Project:	<u>Park Manor Public School Renovation (Phase 2)</u>	WDE File No.:	<u>13694-101</u>
Client:	<u>LGA Architectural Partners</u>	Date:	<u>February 25, 2022</u>
Contractor:	<u></u>	Client File No.:	<u>21970</u>
C.C.:	<u></u>	Addendum No.:	<u>S-01</u>

PROJECT  
**PARK MANOR PHASE 2 INTERIOR AND WINDOW ENHANCEMENTS**  
 18 MOCKINGBIRD DR. ELMIRA, ON.

**PROJECT**  
 PARK MANOR  
 PUBLIC SCHOOL  
 RENOVATION (PHASE 2)  
 18 MOCKINGBIRD DR. ELMIRA, ON.

**S1.0**

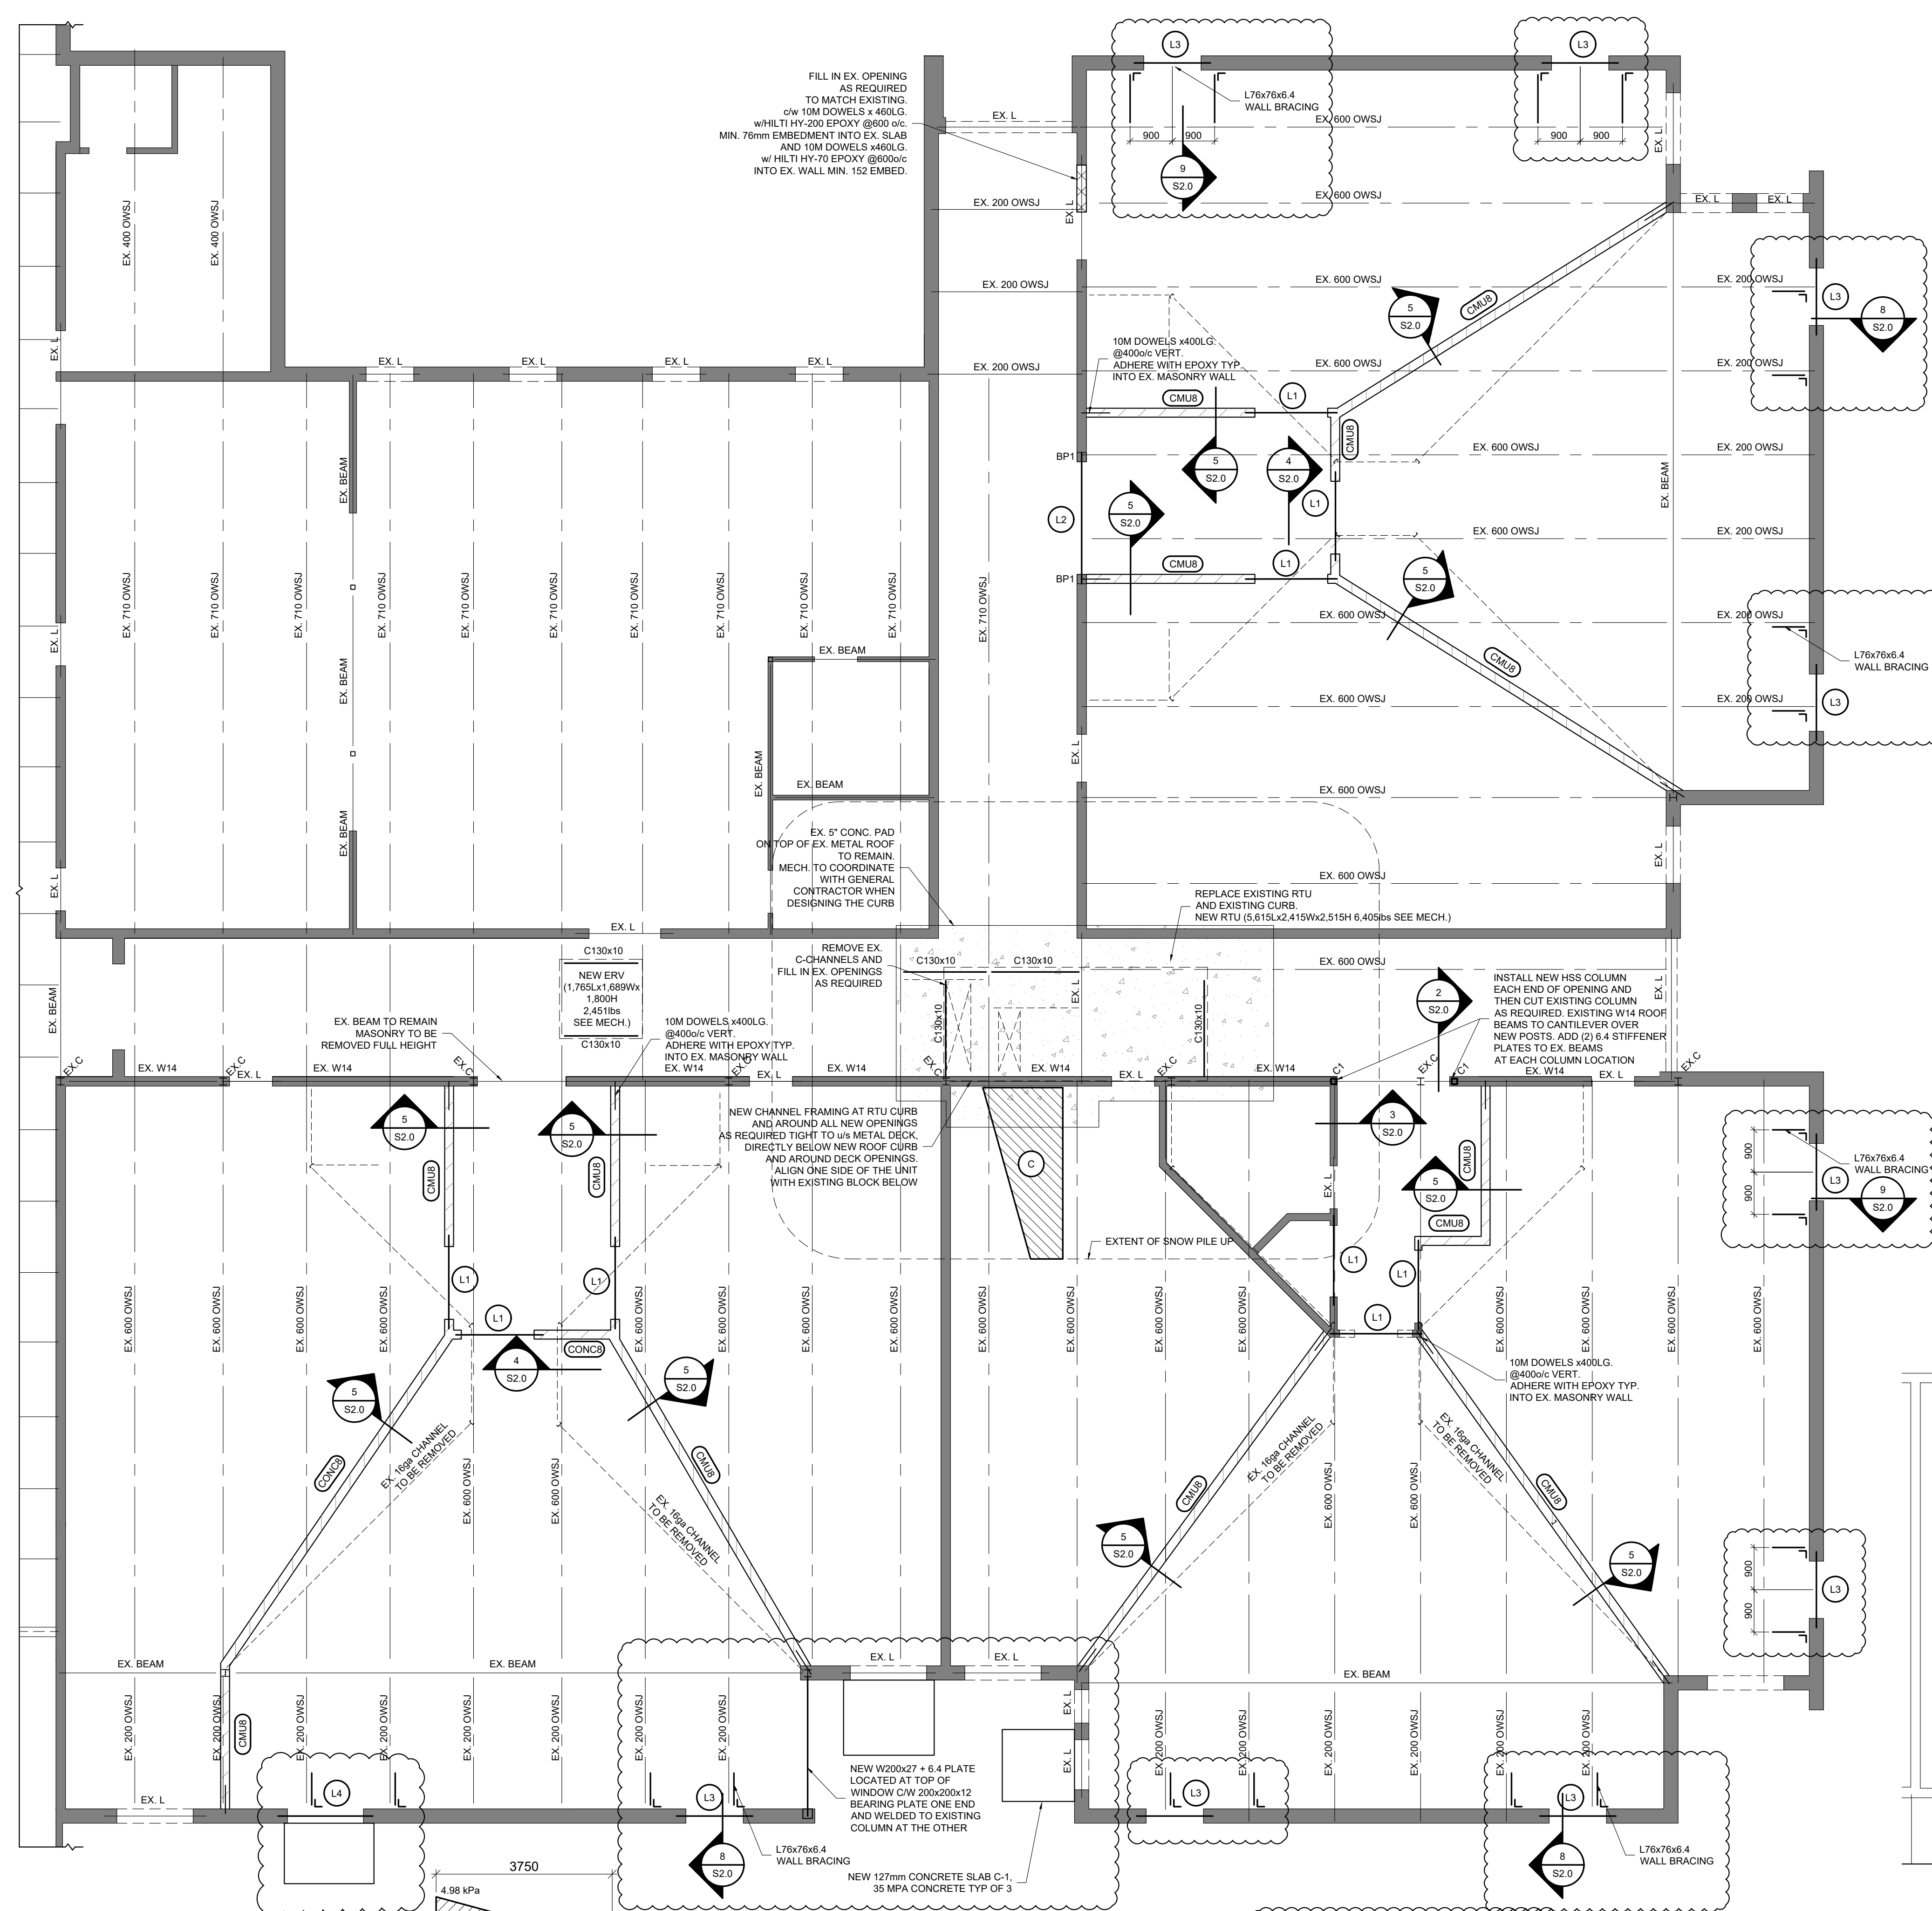
- Revise two L4 lintels to L2 lintels. Refer to drawing S1.0.

DESIGNER	DLN	PROJECT NO.	13694-101
DRAWN	DAR	DRAWING NO.	S1.1
DATE	JANUARY 2022		
SCALE	AS NOTED

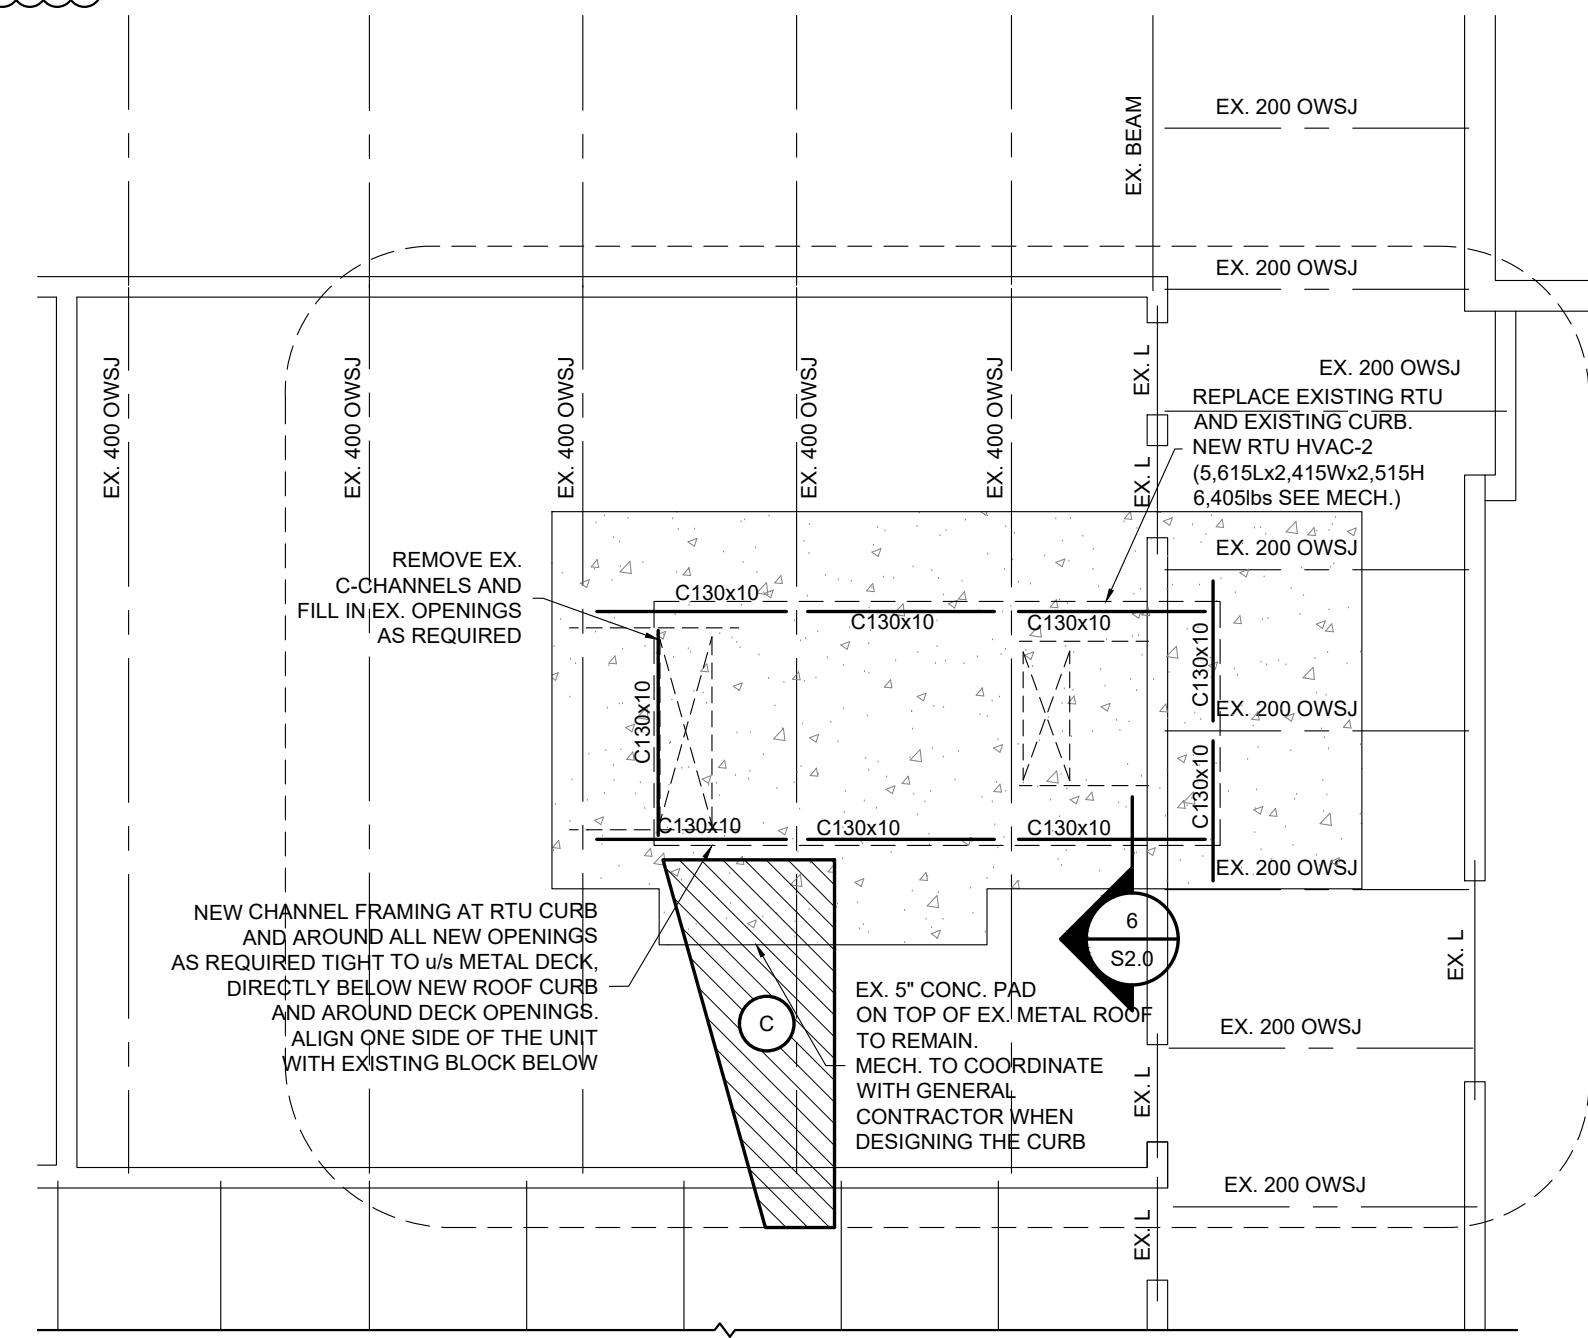
- Provide L76x76x6.4 wall bracing at new exterior wall openings as per details 8 and 9 on drawing S2.0. Refer to drawing S1.1 for locations.

- Provide W200x27 beam above new window in exterior wall in classroom N4. Refer to drawing S1.1.

- Infill masonry wall openings where existing ducting is removed with new concrete block to match existing if new ductwork is not being reinstated. Refer to drawing S1.1.

- Provide 127mm concrete slab at new exit doors. Refer to drawing S1.1.
